ADDENDUM THREE

Memorial Park Improvements
604 Hazel Street
Auburn, IN 46706

Commission No.: F23059

Addendum Date: 16 August 2024

3 Drinking Fountain Shade Structure

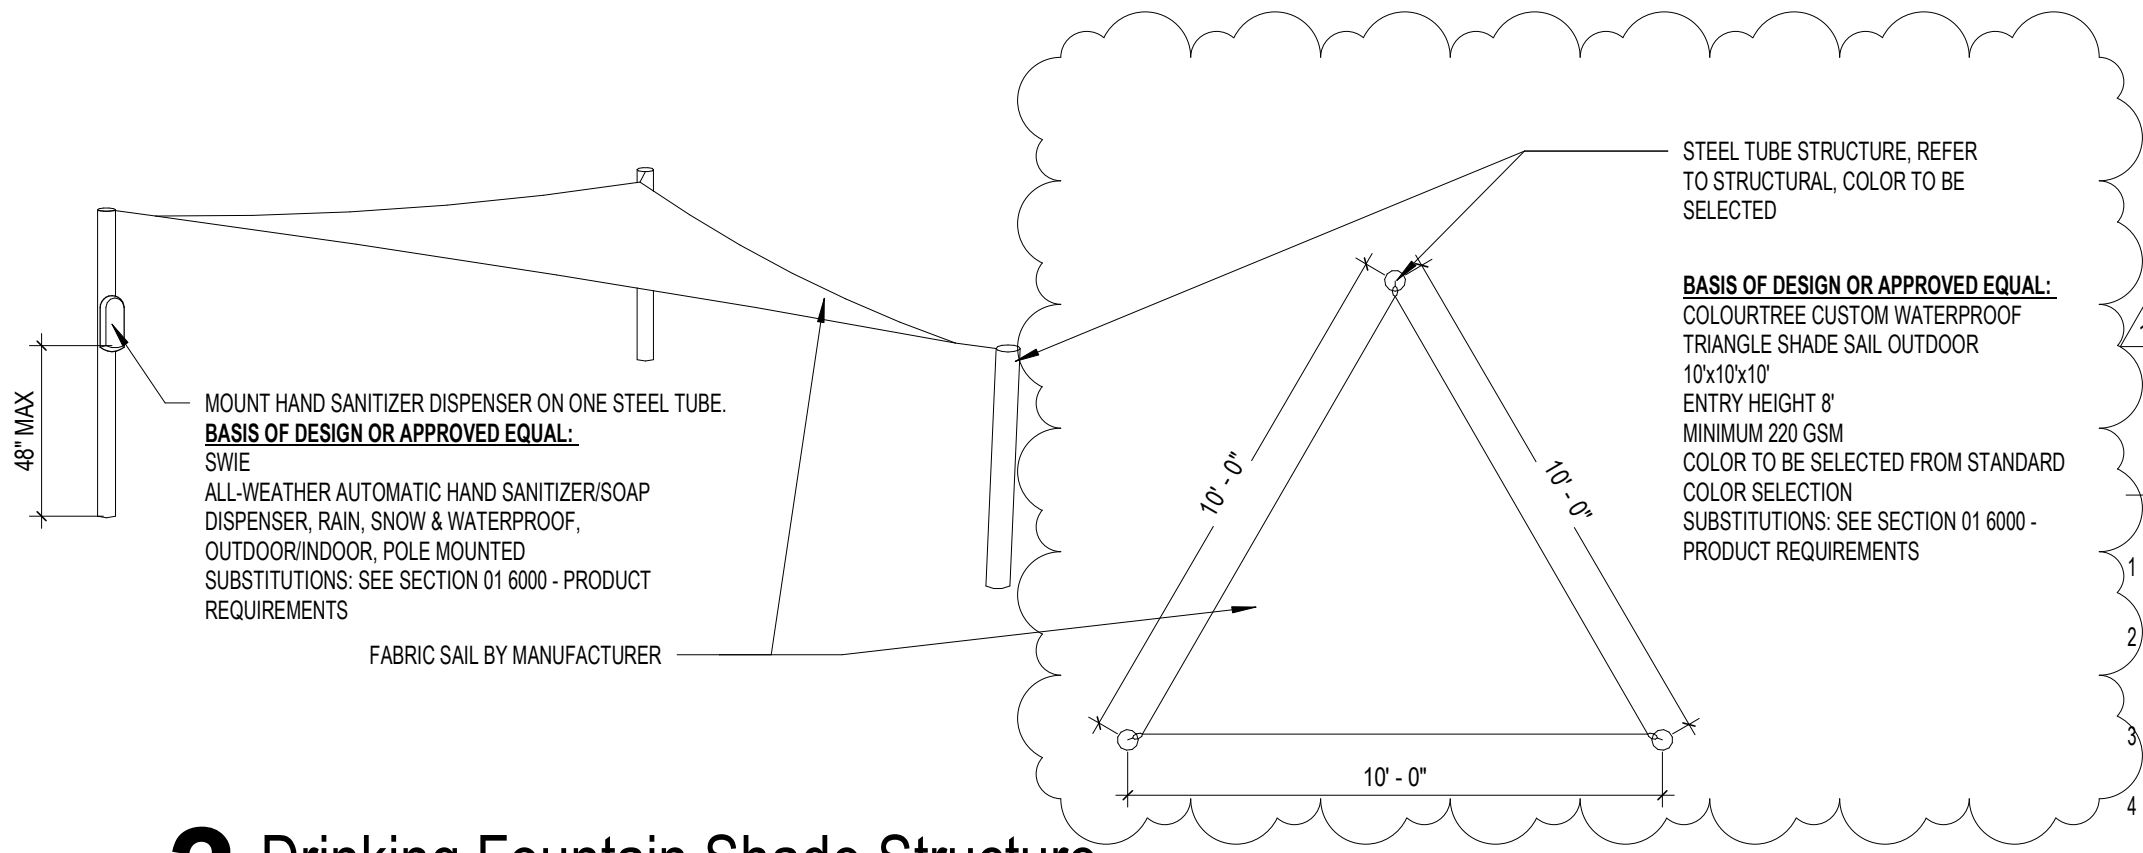
- DRAWING #3 DRINKING FOUNTAIN SHADE STRUCTURE
 - **MODIFY** detail, Equilateral triangle shade sails shall be 10x10x10 feet in lieu of 8x8x8 feet

6 Womens Restroom - South Elevation

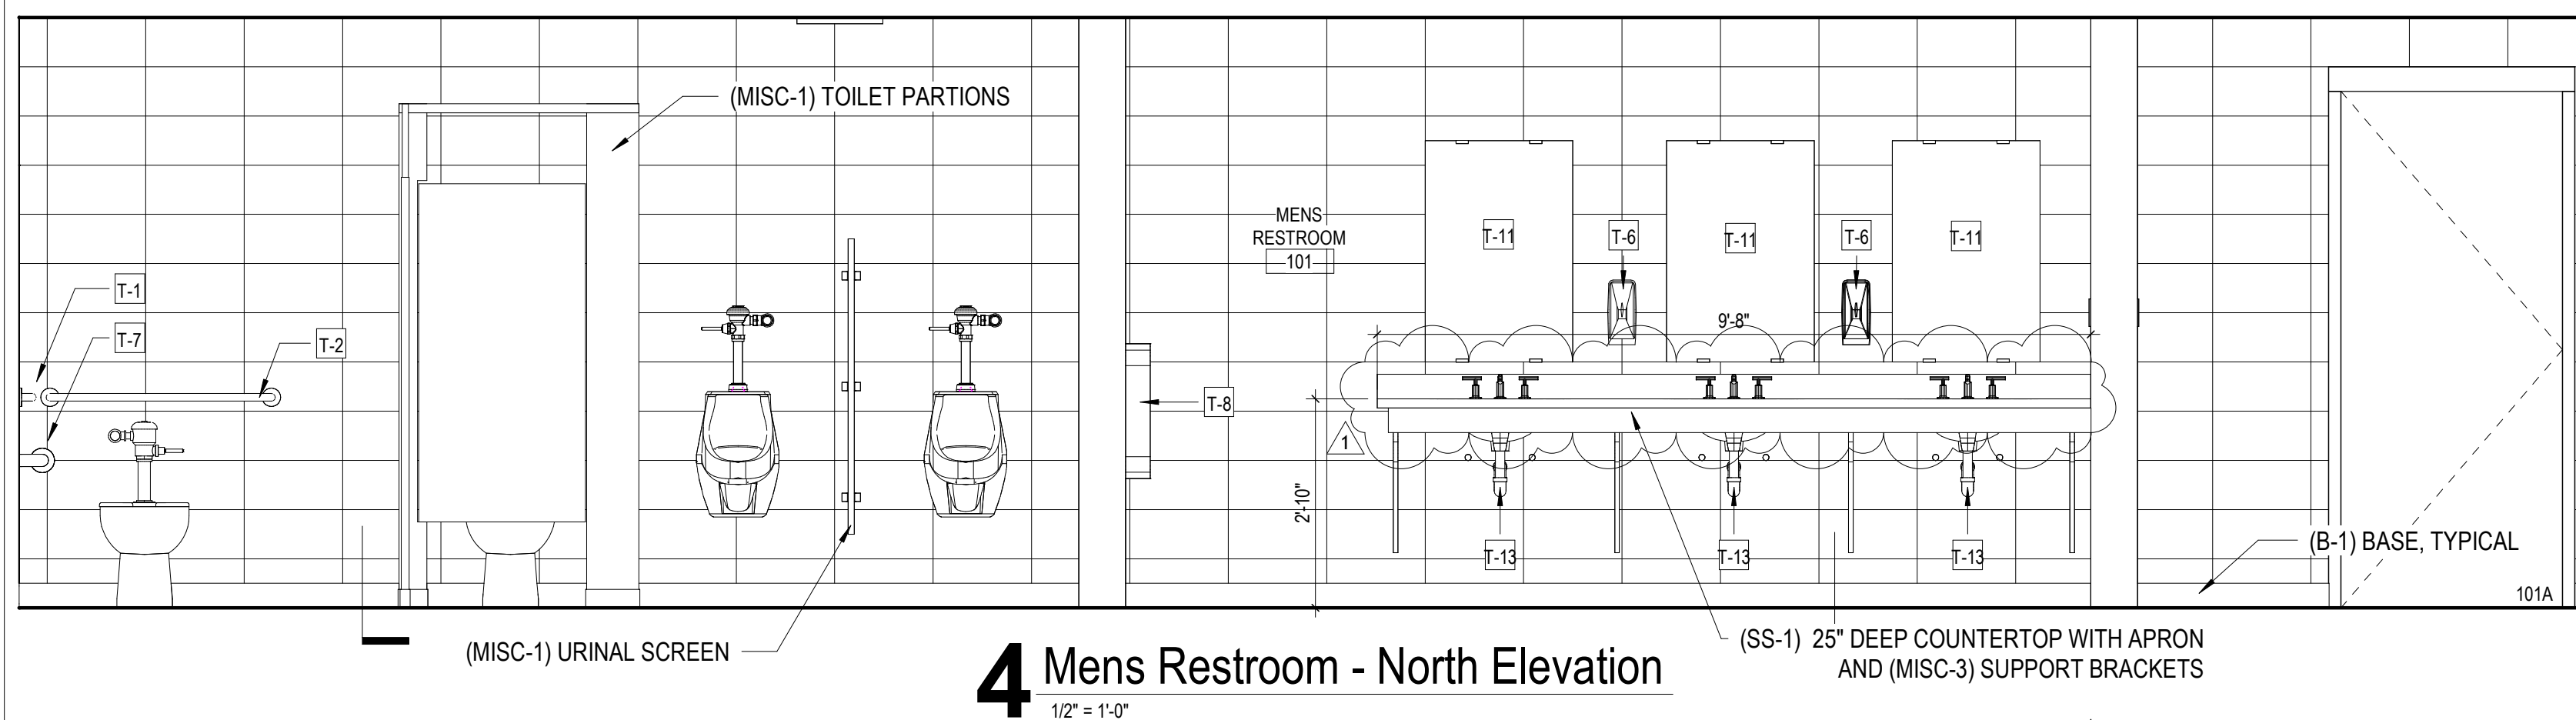
- SECTION DRAWINGS 4 AND 6:
 - **MODIFY** countertop to show integral backsplash
- TOILET ACCESSORY SCHEDULE
 - **MODIFY** toilet tissue dispenser, Item #T-7

Enlarged Site Layout Plan

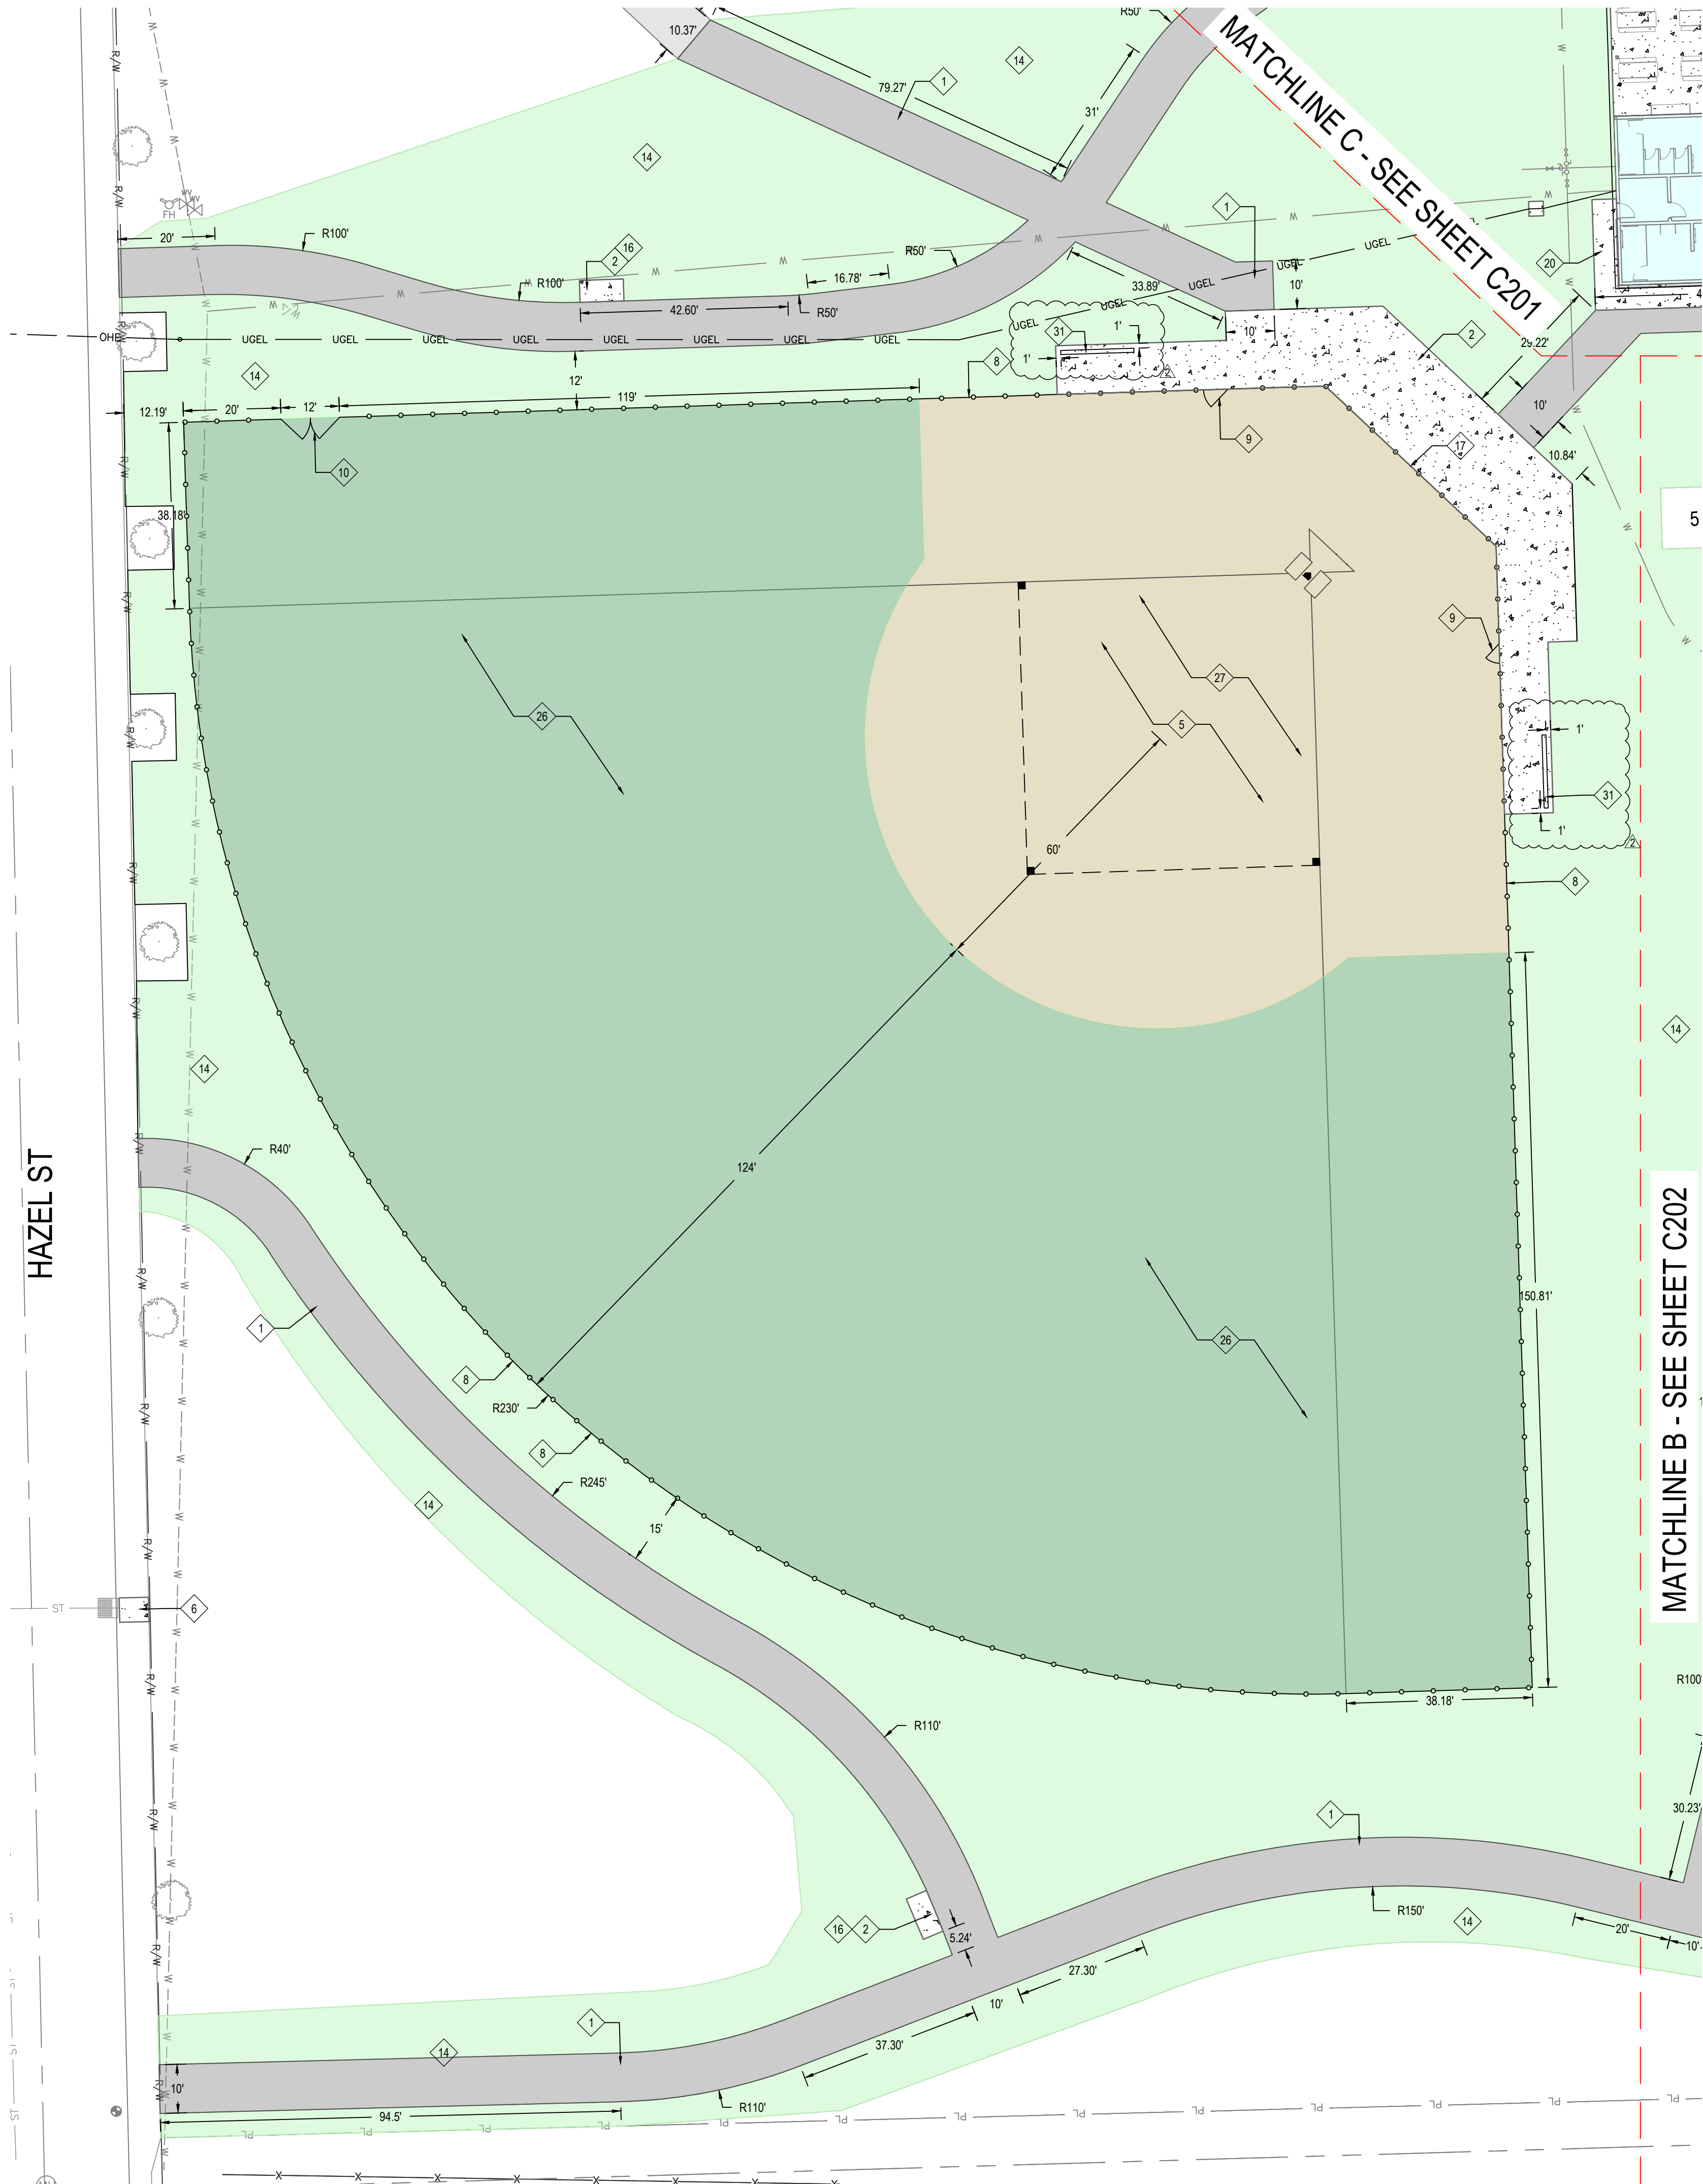
Is there a preference to which model is used as long as it fits that? I'm also not seeing any callout on the plans for location or quantity. How many benches will need to be in each of the two dugout areas?

- **REVISIONS INCLUDE:**
 - **ADD** word description note 31 "DOGOUT BENCH - BASIS OF DESIGN: KAY PARK RECREATION; <https://kaypark.com/> - SUBSTITUTIONS: SEE SECTION 01 6000 - PRODUCT REQUIREMENTS" and depicted Dogout Bench on concrete pad

No preference is given so long as the provided bench meets the specification criteria listed. Refer to updated C203 drawing.

4 Water Fountain
1/4" = 1'-0"

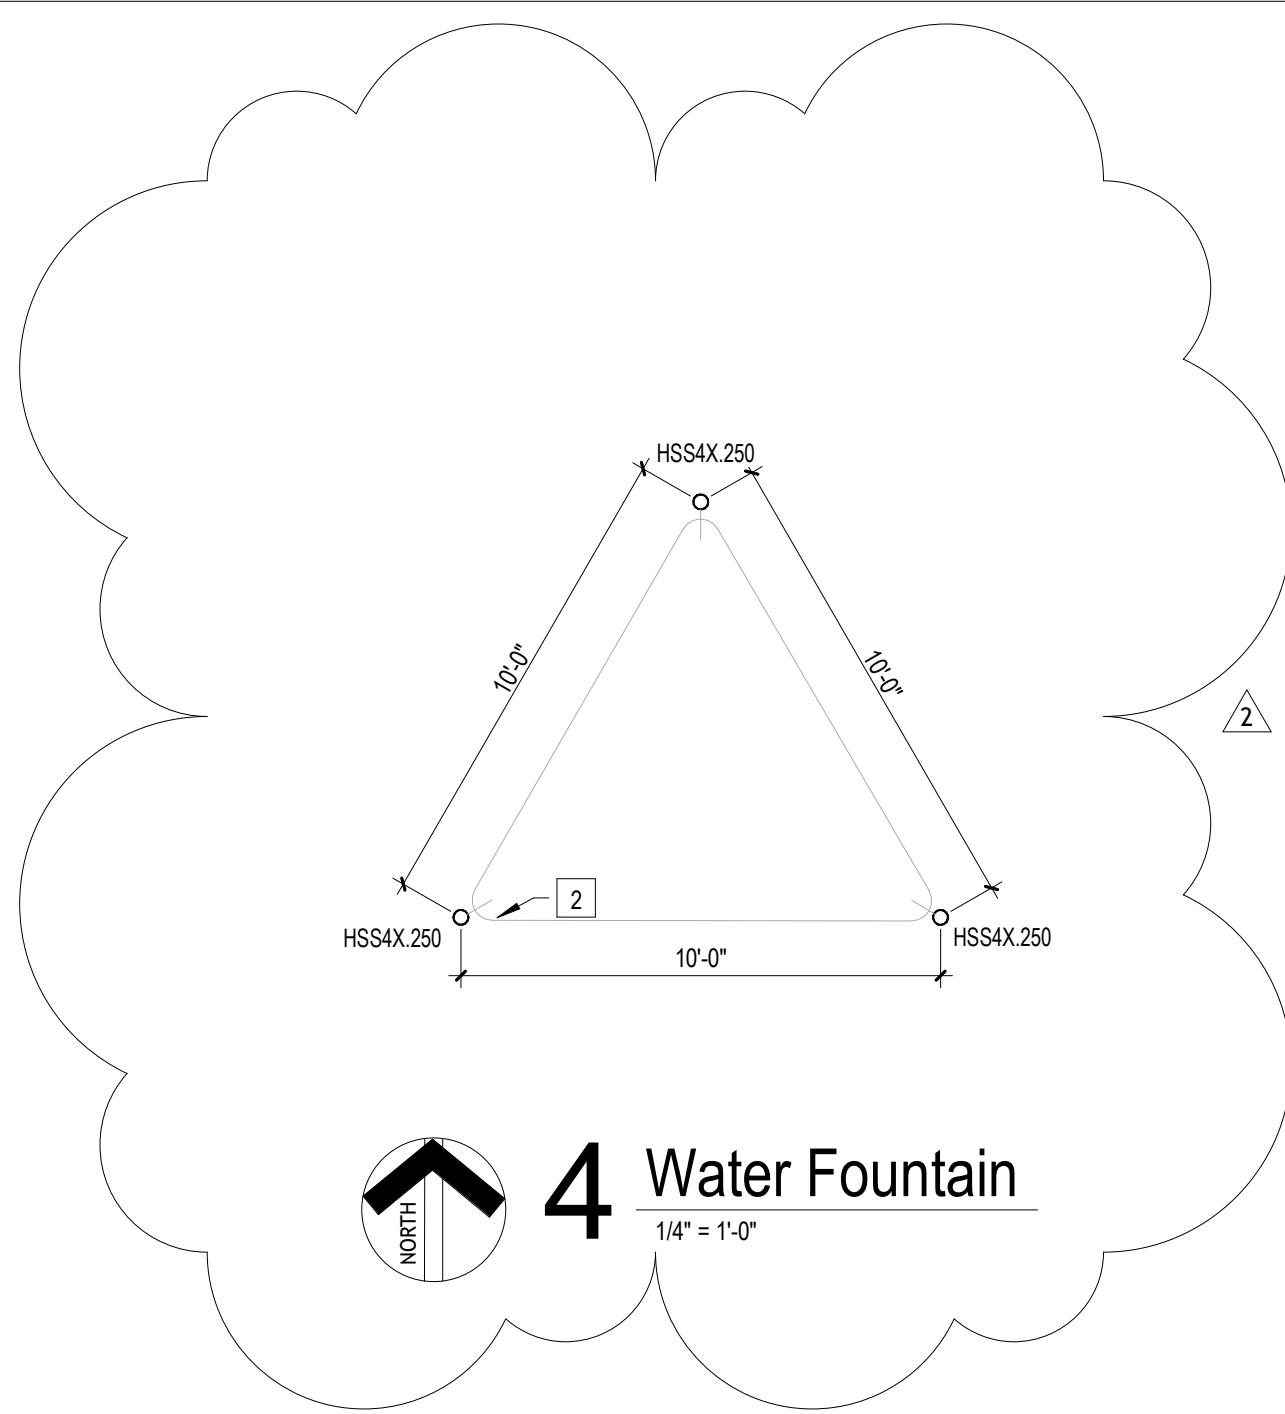
- DRAWING #3:
 - **MODIFY** shade sail posts and depiction
